THM 700-R4 "UPDATE HANDBOOK"

AUTOMATIC TRANSMISSION SERVICE GROUP

Figure 49

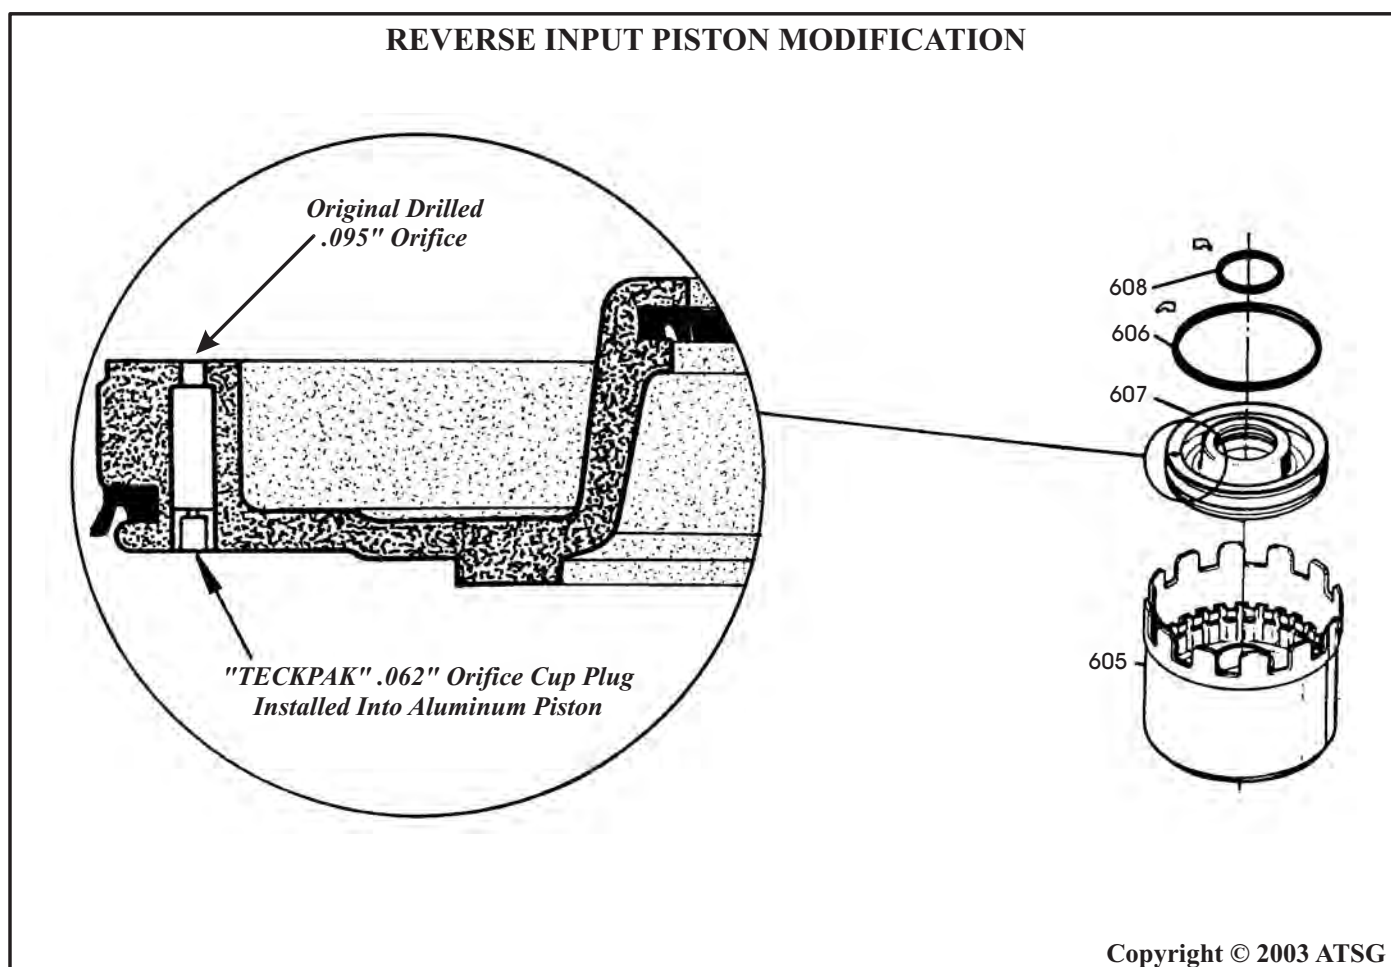
COMPLAINT: Premature failure of the Reverse Input Clutches on 1987-Up models with the aluminum reverse input clutch piston, as shown in Figure 49.

CAUSE: The cause may be, too large of an orifice in the new design "Feed-Bleed" system in the new design aluminum piston, as shown in Figure 49.

CORRECTION: Install an orifice cup plug that has a .062" orifice and is available from "Teckpak" in packages of 10, under their part number 77761C. This orifice cup plug should be installed into the back side of the piston, as shown in Figure 49. We recommend doing this procedure on all overhauls.

Figure 50

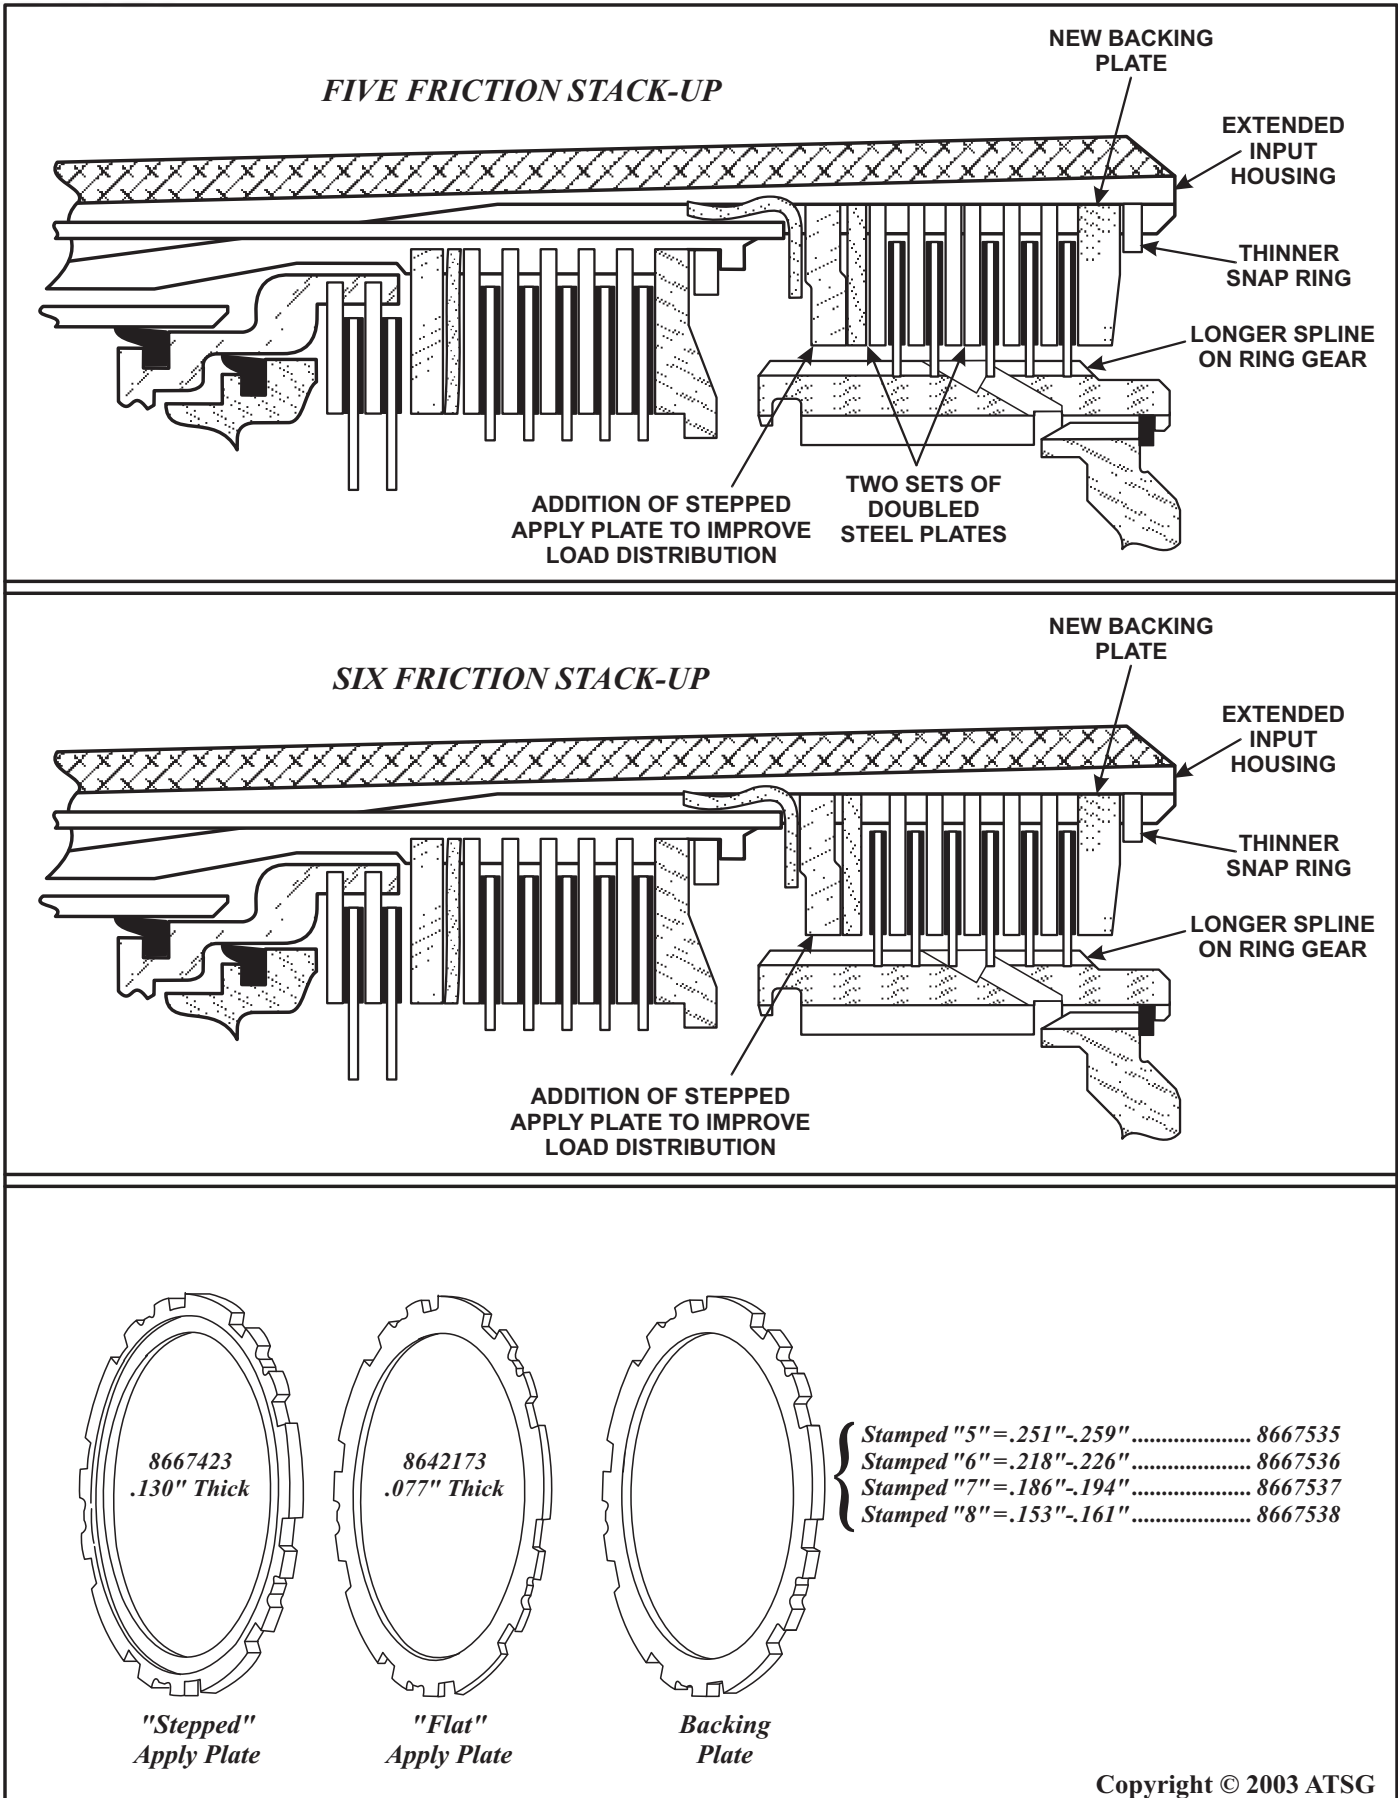
CHANGE: Beginning on February 9, (Julian Date 040) 1987, there was a new 3-4 clutch apply package implemented that included the addition of a "Stepped" 3-4 clutch apply plate, in all models, as shown in Figure 50.

- (1) 3-4 CLUTCH STEPPED APPLY PLATE - Added in both the 5 plate and 6 plate 3-4 clutch stack-ups, as shown in Figure 50.
- (2) INPUT HOUSING ASSEMBLY - Increased in length to help accommodate the added stepped apply plate in the 3-4 clutch pack, as shown in Figure 50.
- (3) 3-4 BACKING PLATE SNAP RING - Backing plate snap ring is now thinner to help accommodate the added stepped apply plate, as shown in Figure 50.
- (4) 3-4 CLUTCH BACKING PLATE - There are now four new thickness backing plates to ensure proper 3-4 clutch clearance which should be .060" to .070". We have provided you with the new dimensions and part numbers for the backing plates in Figure 50.
- (5) INPUT INTERNAL RING GEAR - Now has longer splines to accommodate the extended length of the new input housing and the addition of the stepped apply plate.

3-4 "Stepped" Apply Plate (1 Required)	8667423
3-4 Steel Plate, WithWide Tabs (1 Required)	8642173
3-4 Steel Plate, WithoutWide Tabs (5 or 7 Required)	8663633
3-4 Friction Plates, (5 or 6 Required)	8654145
3-4 Backing Plate (Selective Stamped "5")	8667535
3-4 Backing Plate (Selective Stamped "6")	8667536
3-4 Backing Plate (Selective Stamped "7")	8667537
3-4 Backing Plate (Selective Stamped "8")	8667538
3-4 Clutch Backing Plate Snap Ring (Thinner)	8663636
Input Internal Ring Gear (Longer Splines)	8663639

Figure 51

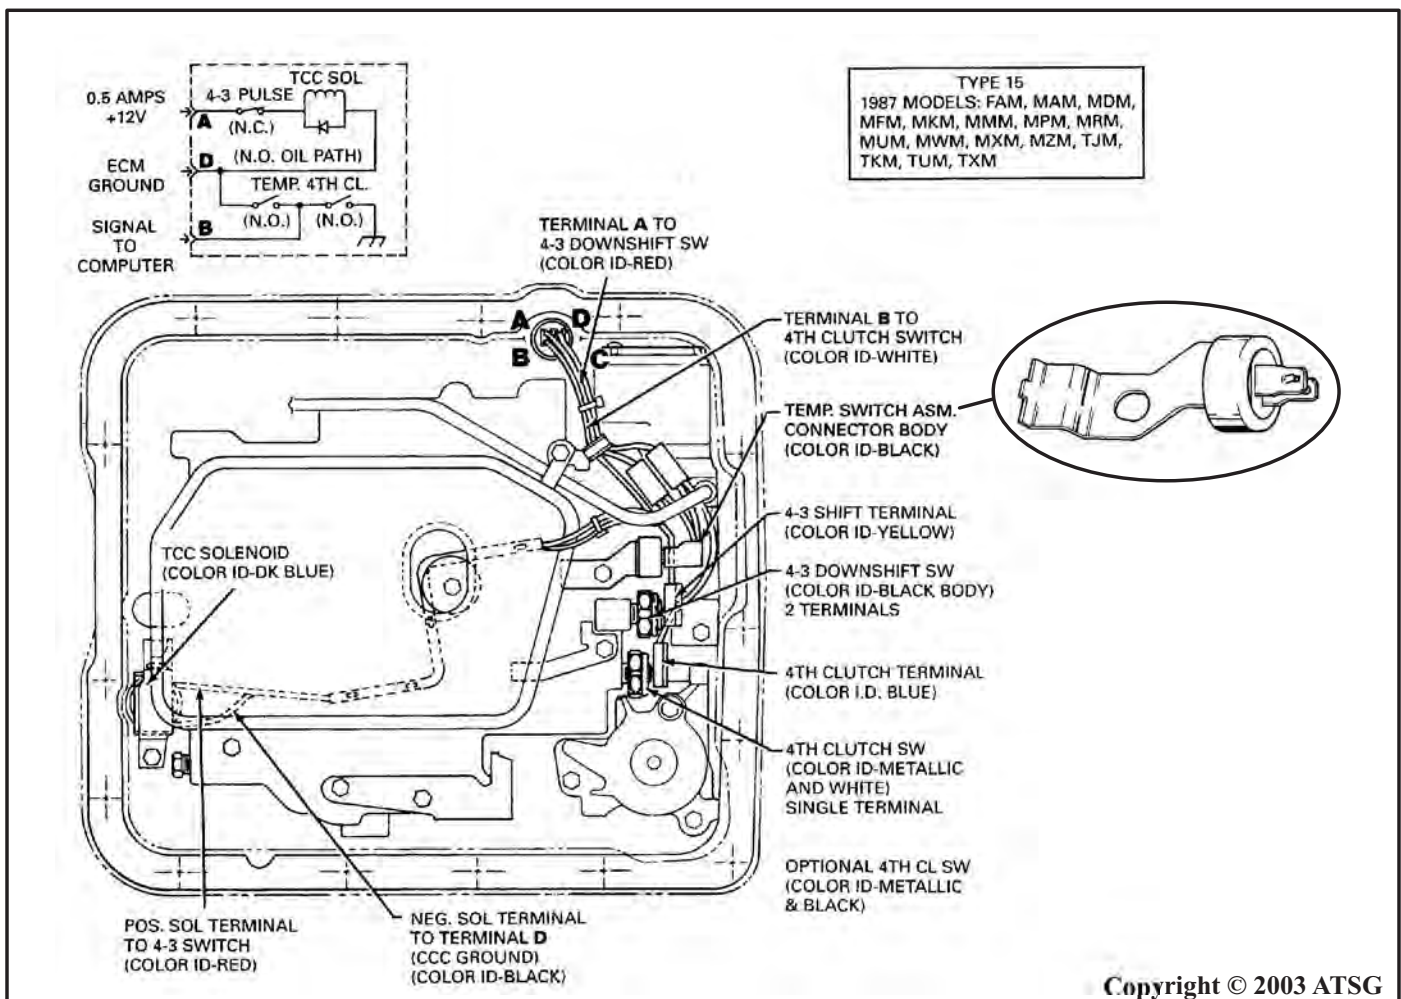
CHANGE: Beginning on June 28, (Julian Date 179) 1987, there was a new internal temperature switch that went into production on some models, as shown in Figure 51.

REASON: The new Temperature Switch mounts on the valve body and is submerged in transmission fluid in the oil pan, as shown in Figure 51. The temp switch supplies an alternate ground path for the TCC solenoid and applies the converter clutch when sump temperatures reach 125-135C (259-275F) and the transmission is in 4th gear.

- (1) TEMPERATURE SWITCH - Added on the date shown above and mounts on the valve body, as shown in Figure 51.
- (2) INTERNAL WIRING HARNESS - A new Type-15 solenoid and wiring harness assembly was need to accommodate the new temperature switch. The Type-15 wiring harness can be identified by a dark blue insulator and number 4415 cast into the top of insulator.

Cannot be used on any previous models and affects only the models listed in Figure 51.

Temperature Switch	8654421
Type-15 Solenoid/Internal Wiring Harness	8654415

Figure 52

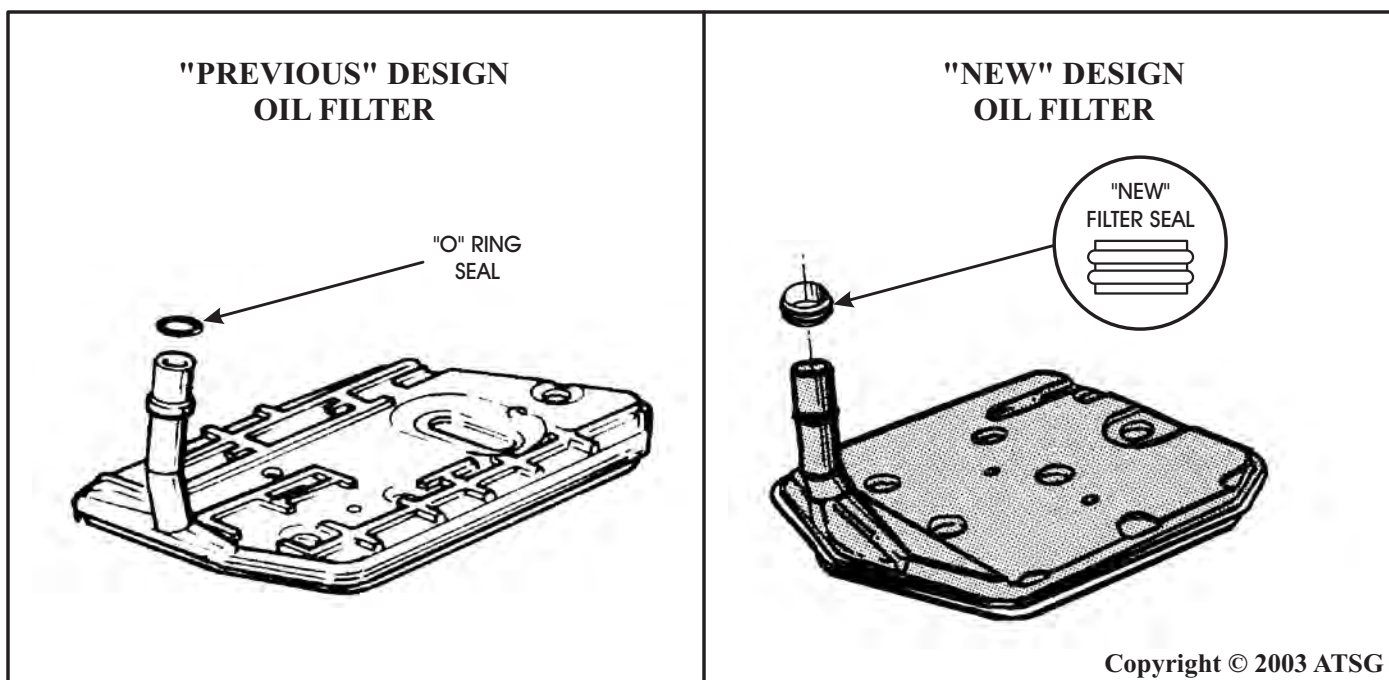
CHANGE: Beginning on July 6, (Julian Date 187) 1987, there was a new oil filter and oil filter seal that went into production on all models of the THM 700-R4, as shown in Figure 52.

- (1) OIL FILTER - The new design filter is wider, has a felt media type element in place of the previous screen, and is bottom suction instead of top suction, as shown in Figure 52.
- (2) OIL FILTER SEAL - The new design seal is two rubber lips molded to a steel sleeve and the seal is glued onto the filter neck, as shown in Figure 52.

Service Package, Oil Filter and Seal, Pan Gasket 8657926

Figure 53

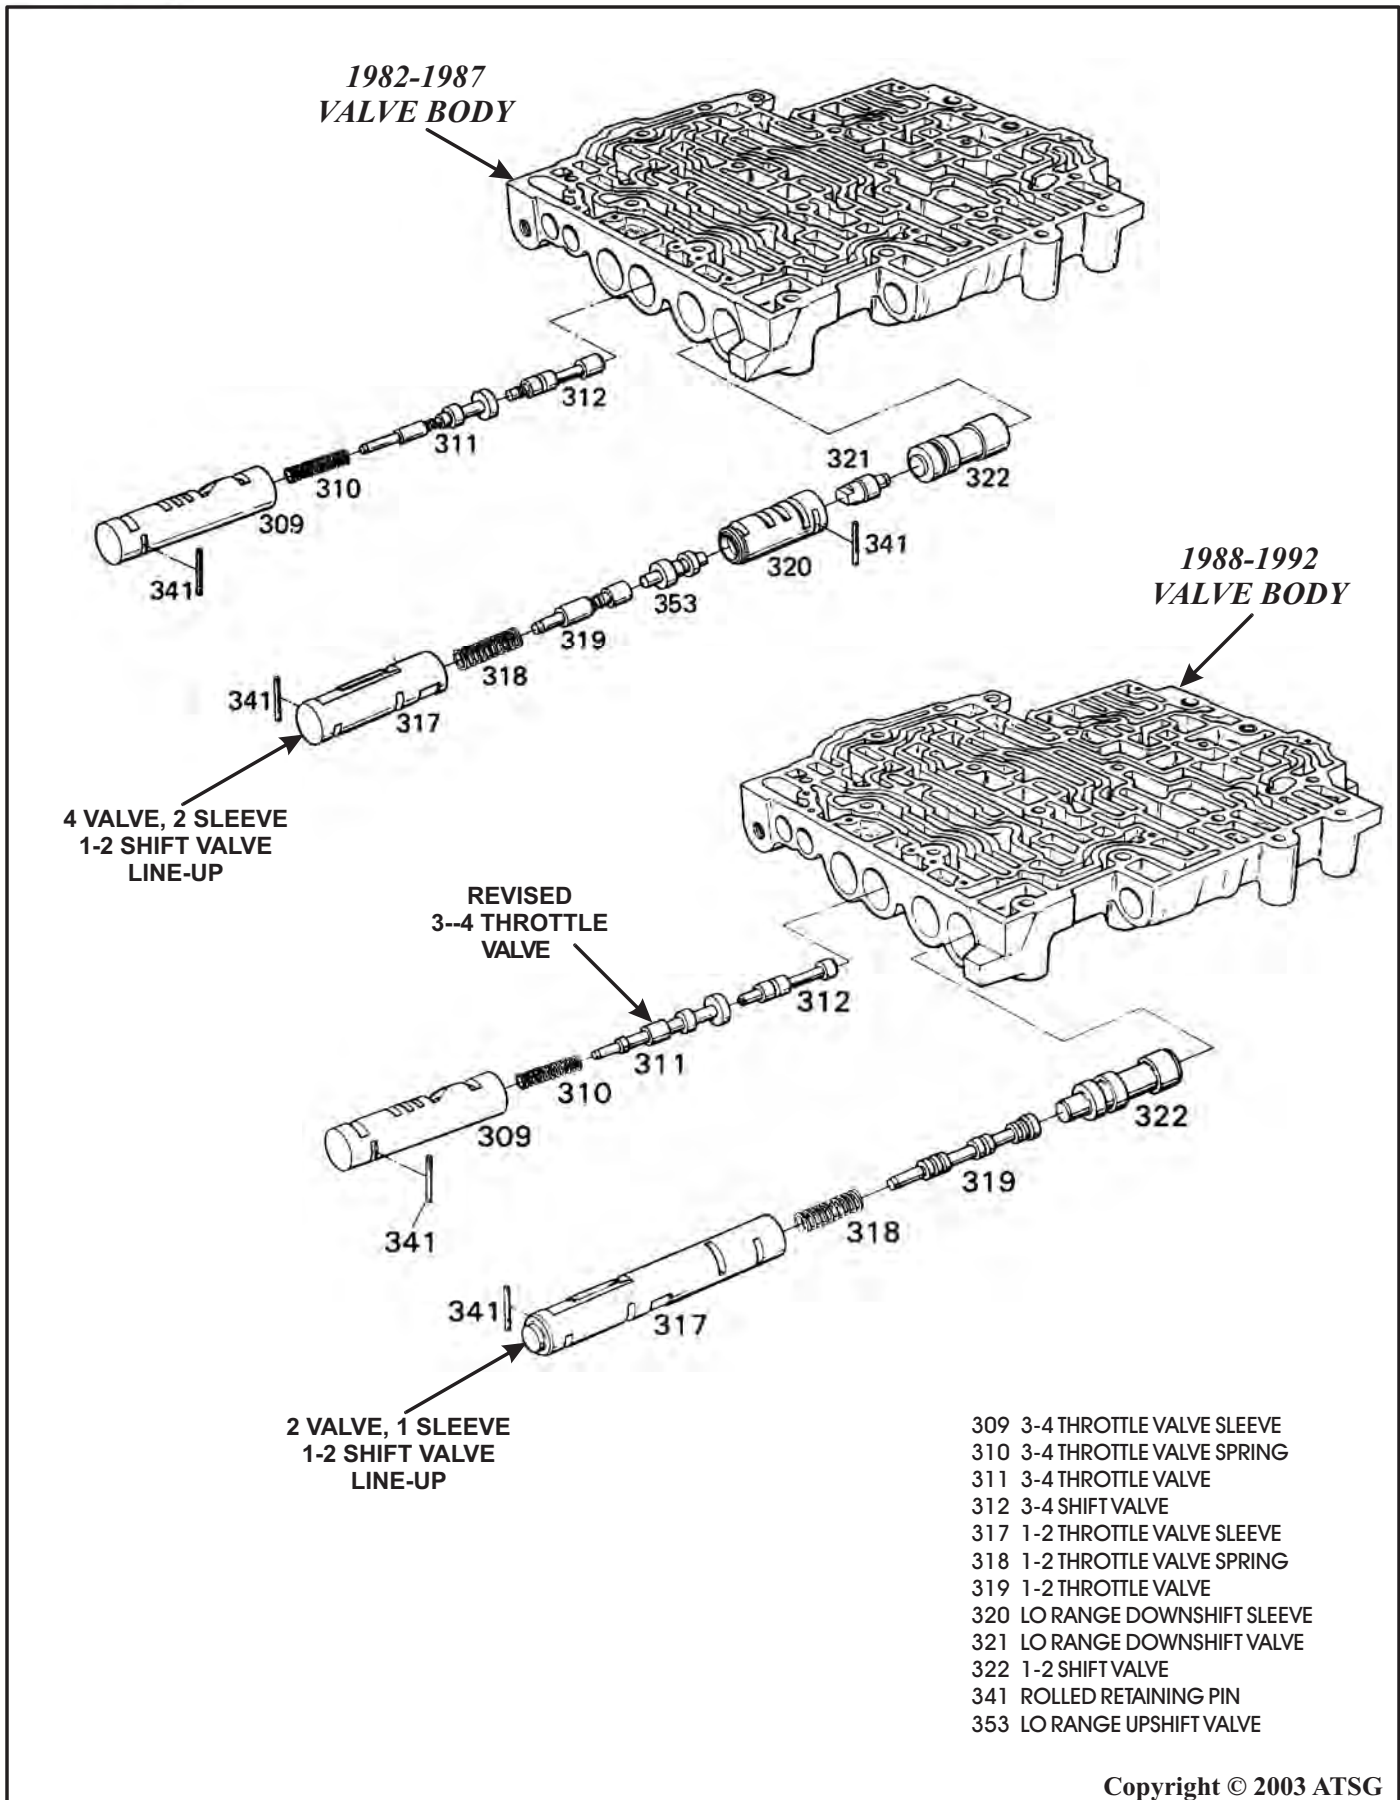
CHANGE: Beginning on July 23, (Julian Date 204) 1988, there was a new design valve body assembly with a revised 1-2 shift valve line-up, and a revised 3-4 throttle valve, as shown in Figure 53.

- (1) 1-2 SHIFT VALVE LINE-UP - The 1-2 shift valve line-up changes from 4 valves and two sleeves, to two valves and one sleeve. The Lo Range Downshift Valve (321), Lo Range Control Sleeve (320), and the 1-2 Lo Range Upshift Valve (353), have been eliminated from the 1988 and later model valve bodies, as shown in Figure 53.
- (2) 3-4 THROTTLE VALVE - The 3-4 throttle valve and sleeve now have revised diameters, as shown in Figure 53.
- (3) SPACER PLATE AND GASKETS - Spacer plate and both gaskets have been revised to accommodate the changes in the 1-2 shift valve line-up, and also changes over the case bathtub where the number 9 checkball was eliminated, as shown in Figure 54.
- (4) NUMBER 9 CHECKBALL - The number 9 checkball located in the bathtub in the case location shown in Figure 54, has been eliminated.

Refer to Pages 32 through 37 for spacer plate identification and part numbers for 1987-1993 models of the THM 700-R4 transmissions.

Figure 55

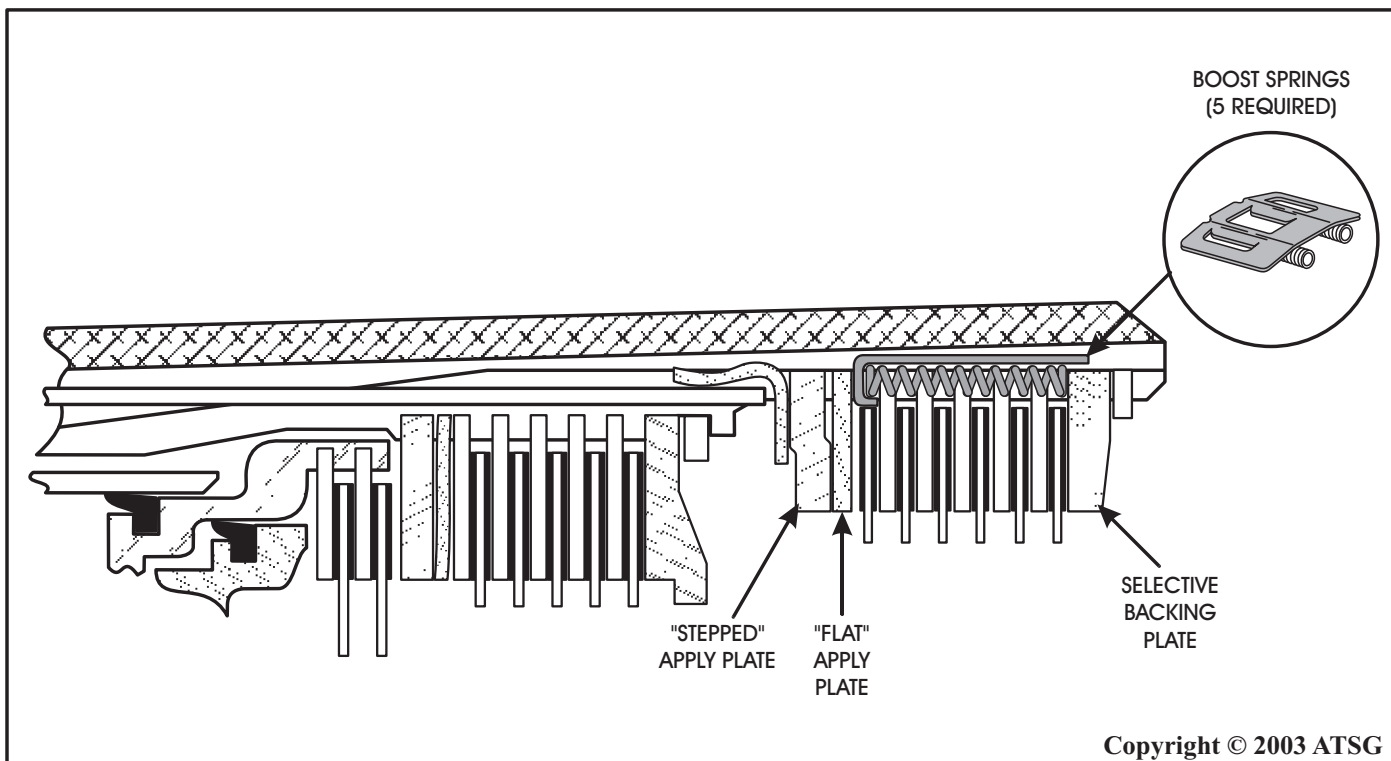
CHANGE: Beginning on July 23, (Julian Date 204) 1988, there were five 3-4 clutch boost springs added between the backing plate and the apply plate in the 3-4 clutch pack, as shown in Figure 55. These "load release" springs were added only on the following models, YDM, TMM, YWM, and YZM for the 1988 model year. Beginning in 1989 they were implemented on all models.

- (1) **LOAD RELEASE SPRINGS** - Added on YDM, YMM, YWM, YZM models only, between the backing plate and the apply plate, as shown in Figure 55. They are located in five equally spaced places around the 3-4 clutch pack, as shown in Figure 57.
- (2) **3-4 CLUTCH STEEL PLATES** - The wide tabs on the 3-4 clutch steel plates were modified to make room for the added load release springs, as shown in Figure 56. However, there is still "One" flat steel plate with the wide tabs required, and is called the flat apply plate. The flat apply plate goes on top of the "Stepped" apply plate, as shown in Figure 56.

3-4 Load Release Springs (5 Required)	8667424
3-4 Clutch "Flat" Apply Plate	8642173
3-4 Clutch "Stepped" Apply Plate	8667423
